# East Fiber Loop Addendum 1

The following is an addendum to the original East Fiber Loop Scope of Work based on questions asked in the walkthrough on 4/8/25.

The bore in question is the red line at the top of the image.

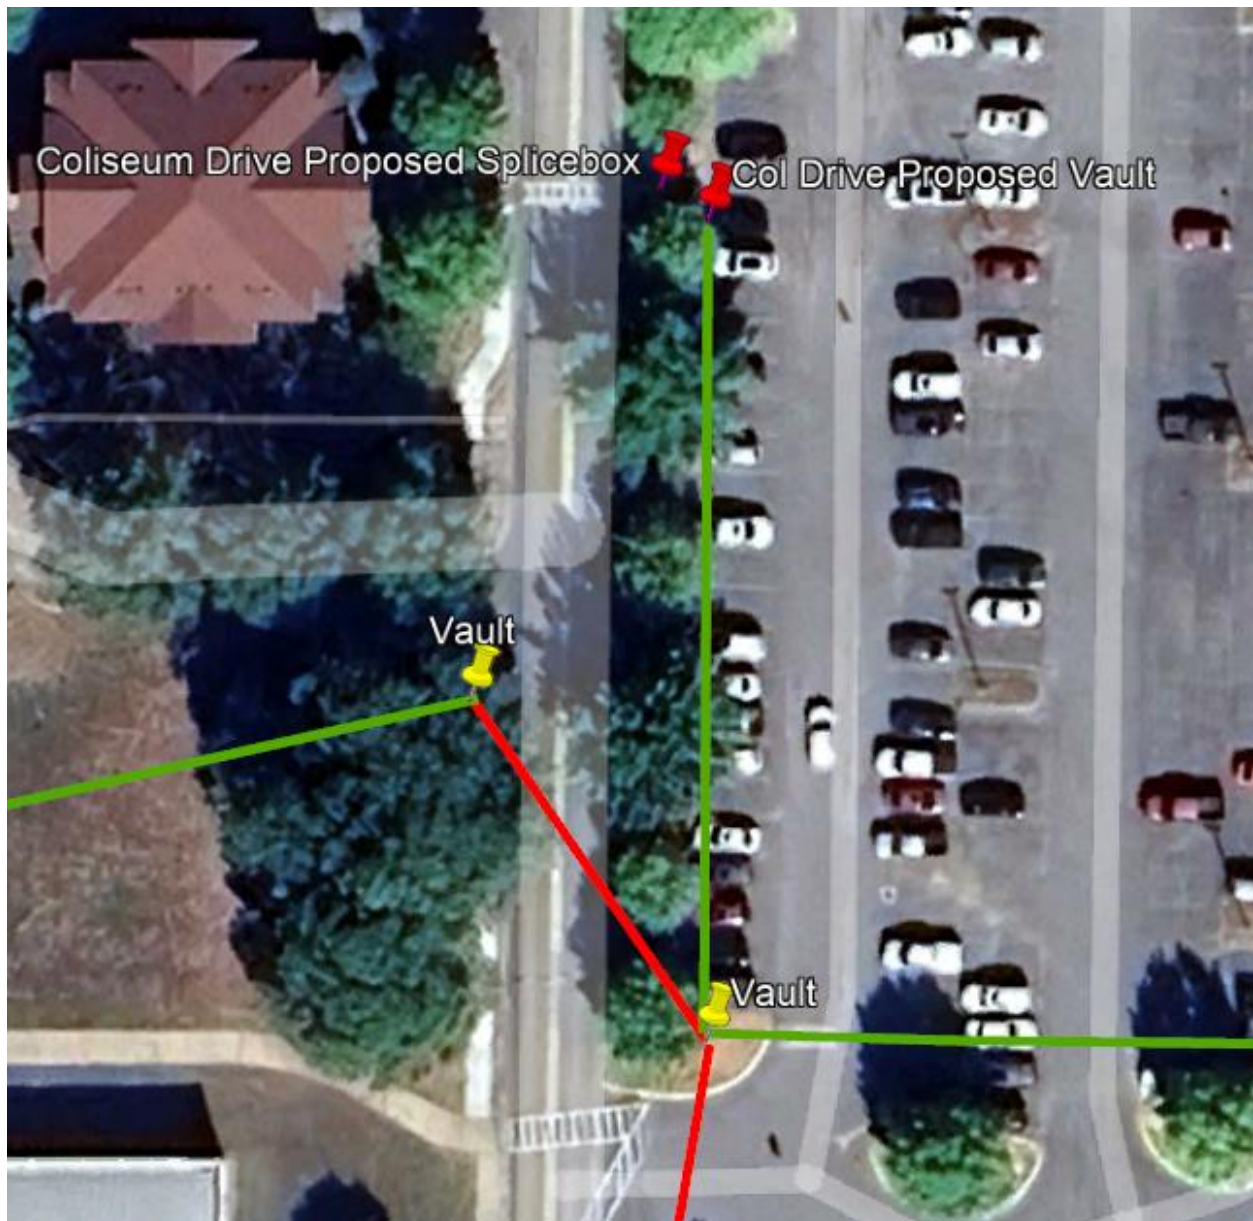
Is the bore from the existing vault on the West side of Coliseum Drive to the new vault on the East side of the road part of the required work or the optional work? Is this the proper path or could the bore go between the two existing vaults?

The bore asked about is shown in Figure 3 of the Scope of Work in the Required Work section and should be considered part of the required work for the base project (that is the parts of the project to be done regardless of what optional parts are chosen to be implemented by ATU based on available budget). For easy reference, the figure in question is shown here:

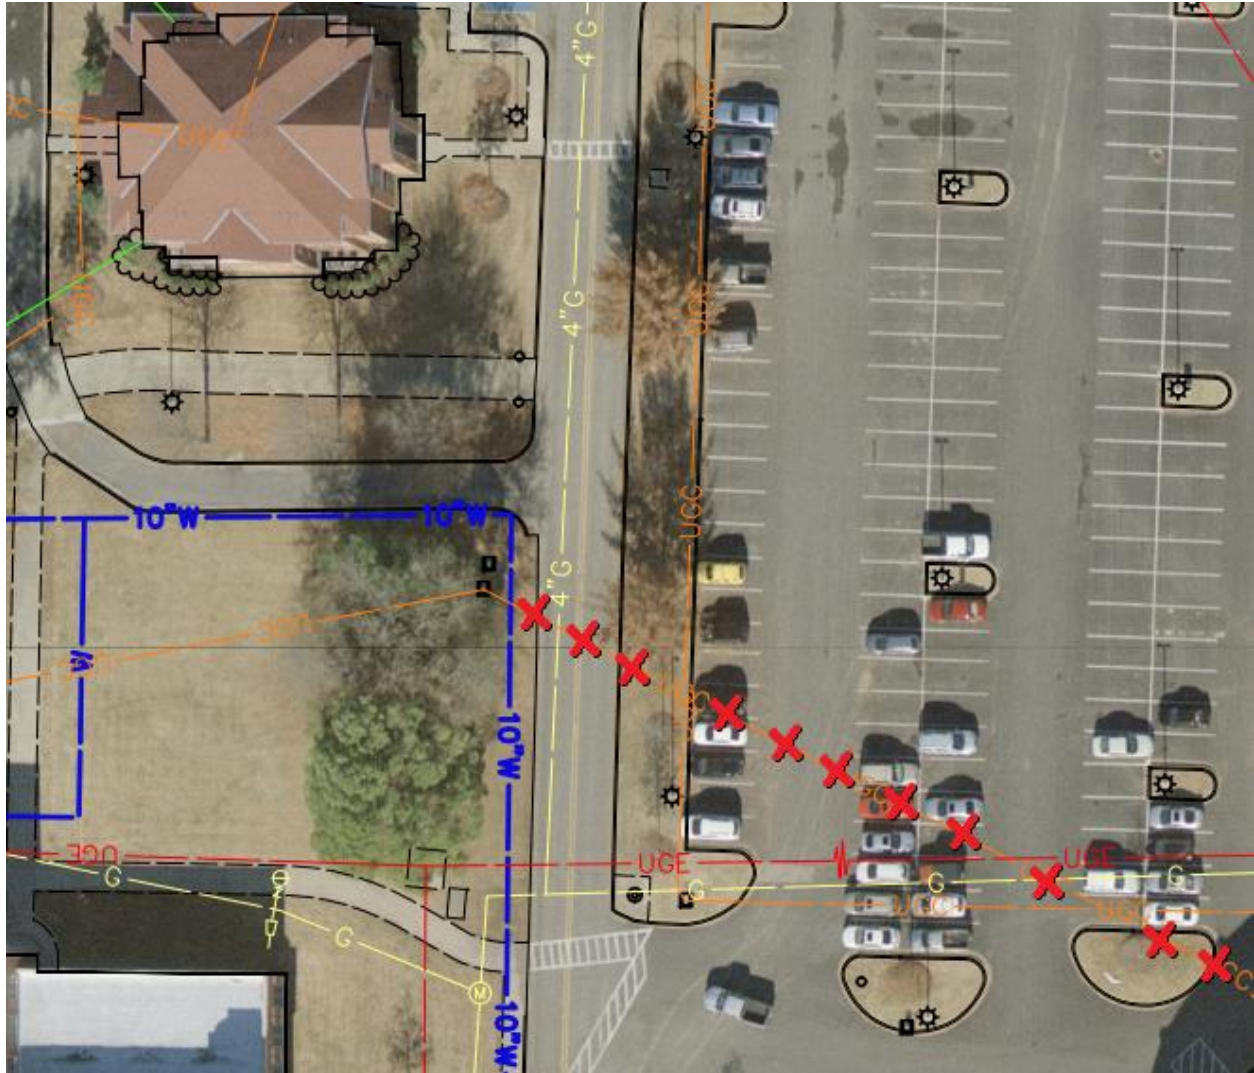
The second part of the question is about which vaults the bore path would connect to. In the above drawing, the bore connects an existing ground vault on the West side of the road (marked with a yellow pin) to a new ground vault to the Northeast on the opposite side of the road (marked with a red pin). The question was if the bore path could instead connect the existing vault on the West side of the road to another existing vault on the opposite side of the road to the Southeast. The following image shows what that could look like:

This is an acceptable alternative assuming there is a cost savings (bearing in mind if Option B is chosen, fiber would then be run in this new path and would require an extra few hundred feet of length to go South first before crossing the road) or improves the ease of the bore in some way.

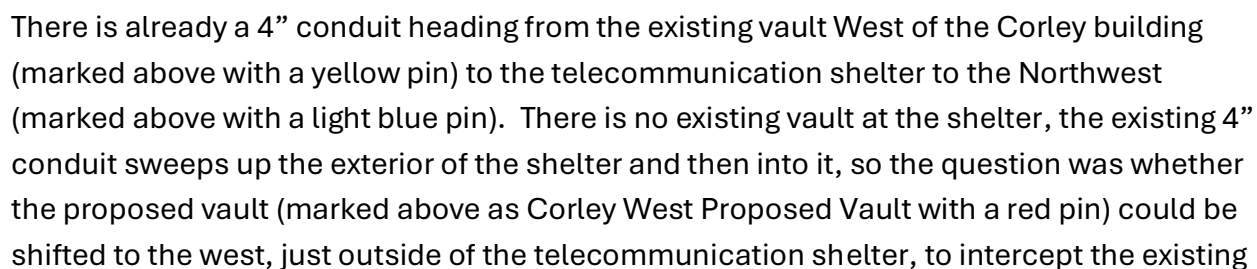
The other considerations are nearby gas and electrical utilities. The following image is an old map but much of this infrastructure may still be in place:

The X'd out orange line already crossing the street from the existing vault on the West side of the road is in an unknown condition, size, and location/path and was not included to re-use in this project.

This question references Figure 7 in the Scope of Work under Option A, also shown below:

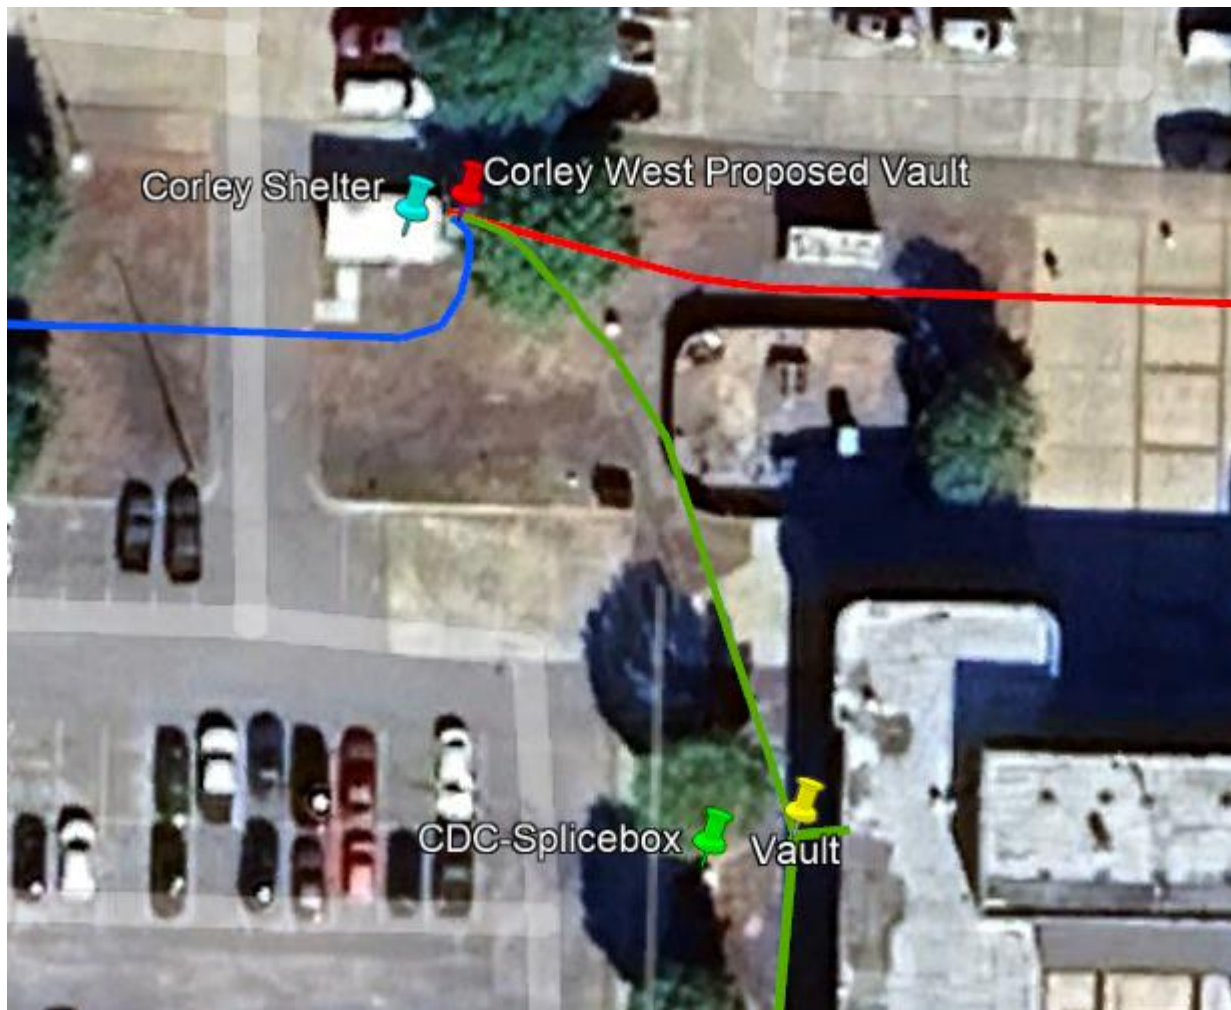
Could the location of the proposed vault to the Northwest of the Corley building be moved to intercept the existing conduit to the shelter, removing the bore from that vault to the existing Corley vault?

4" conduits. The existing 4" conduit going to the vault to the West of the Corley building could then be used instead of a new bore. The result would look like the following:

This proposed change is accepted by ATU for Option A and should be considered to overrule any conflicting information in the original Scope of Work so long as the vault added just outside of the telecommunication shelter fits over both 4" conduit (the second one's estimated path has been shown here in blue). Both conduits then should be cut open inside the new vault to allow access to either, being careful to not damage existing cabling inside. The 4" conduit that proceeds to the existing vault to the Southeast could then be used instead of a new bore.
